# CITY OF ALBUQUERQUE

**RE: Lot 12P1 Block 8B Unit 3 SAD 227  
6401 Little Joe Dr. NW  
Grading and Drainage Plan  
Engineers Stamp Date 2/21/2020 (E10D083)  
Pad Certification Date 8/13/2020**

## DRAINAGE AND TRANSPORTATION INFORMATION SHEET (REV 6/2018)

ENGINEER'S SEAL	6401 LITTLE JOE PLACE	DRAWN BY DEM
DAVID SOULE NEW MEXICO REGISTERED PROFESSIONAL ENGINEER 14522	GRADING AND DRAINAGE PLAN	DATE 8-13-20
8/13/20	Rio Grande Engineering 1608 CENTRAL AVENUE SE SUITE 201 ALBUQUERQUE, NM 87106 (505) 972-0899	6401 LITTLE JOE PL.DWG
		SHEET # C1
		JOB #

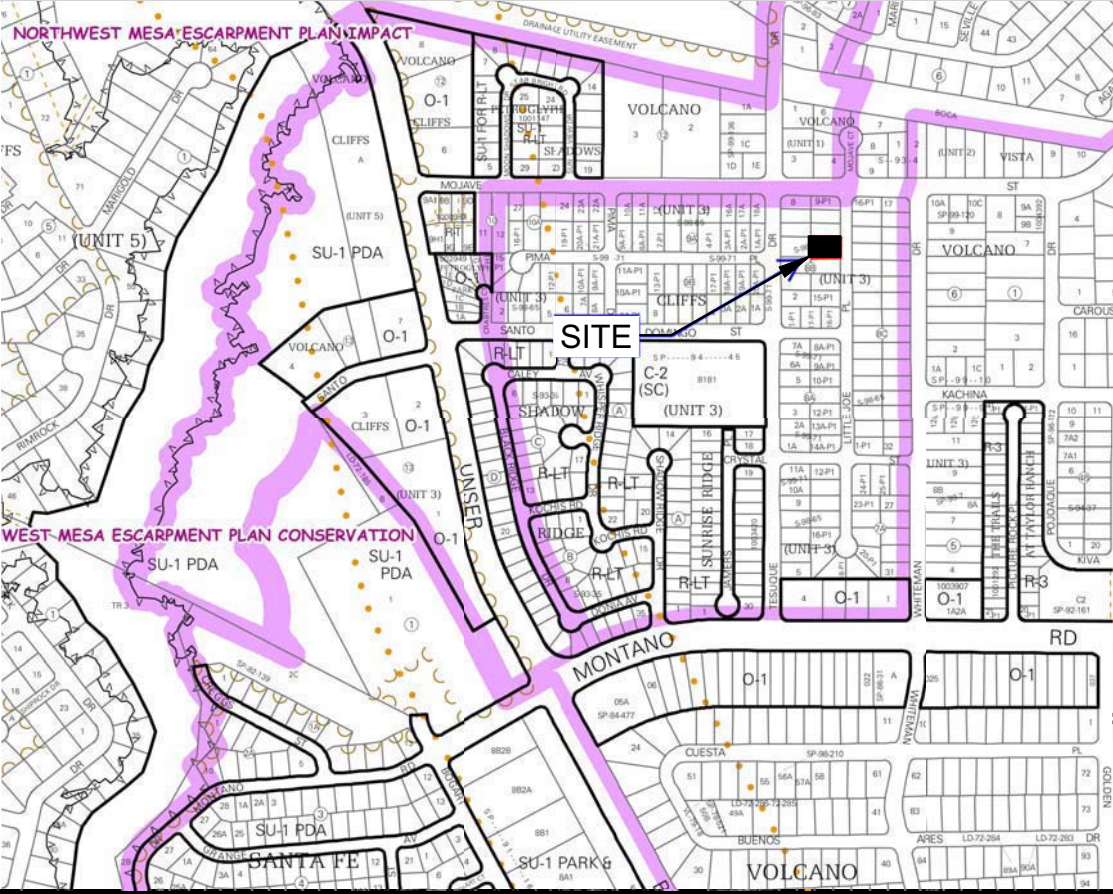
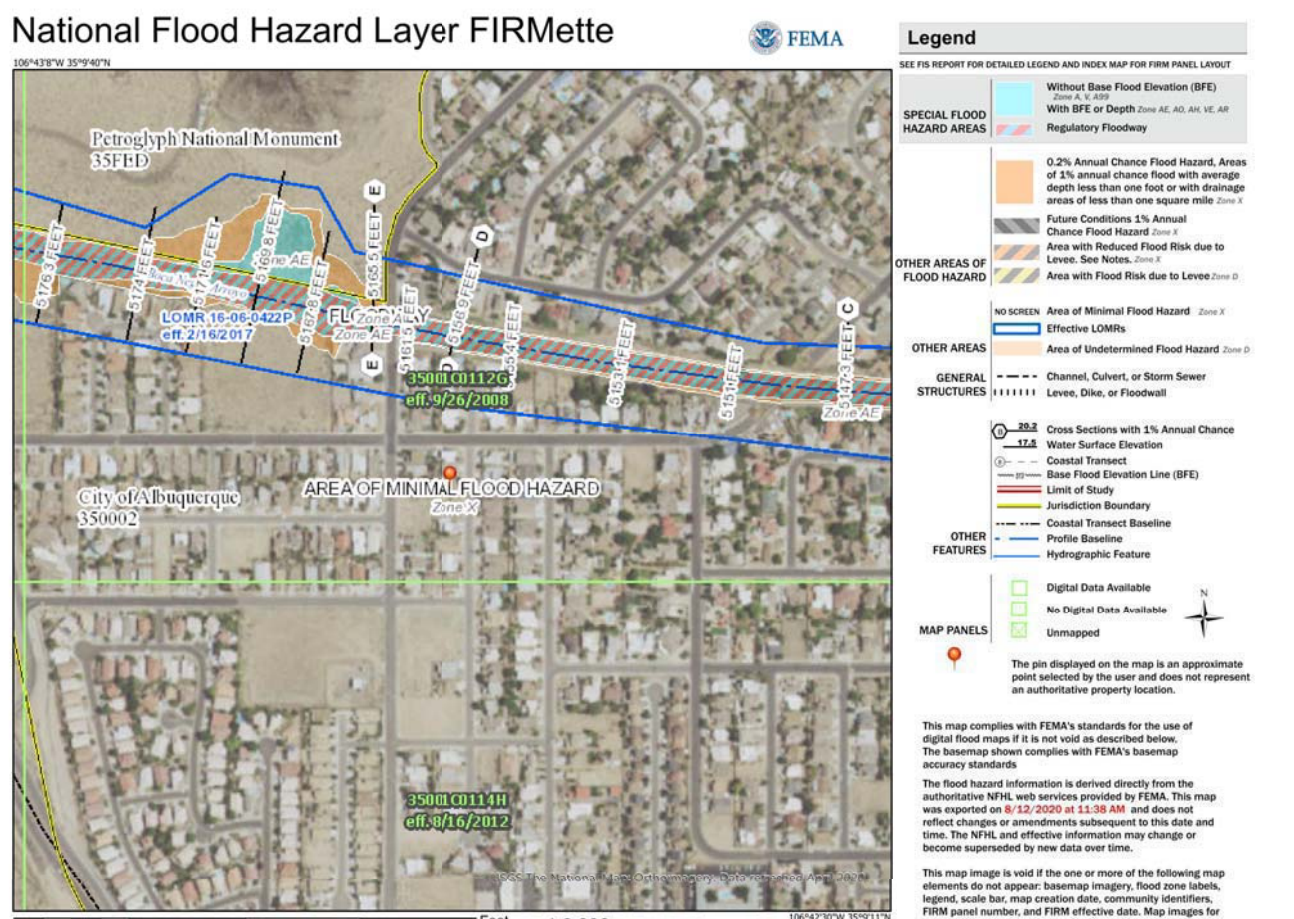
Based upon the information provided in your submittal received 9/30/2020, this plan is approved for Building Permit.

Reiterate to the Owner/Contractor that a separate permit for a garden/retaining wall must be obtained, with the approved G&D plan.

Prior to Certificate of Occupancy release, Engineer Certification per the DPM checklist of this plan will be required.
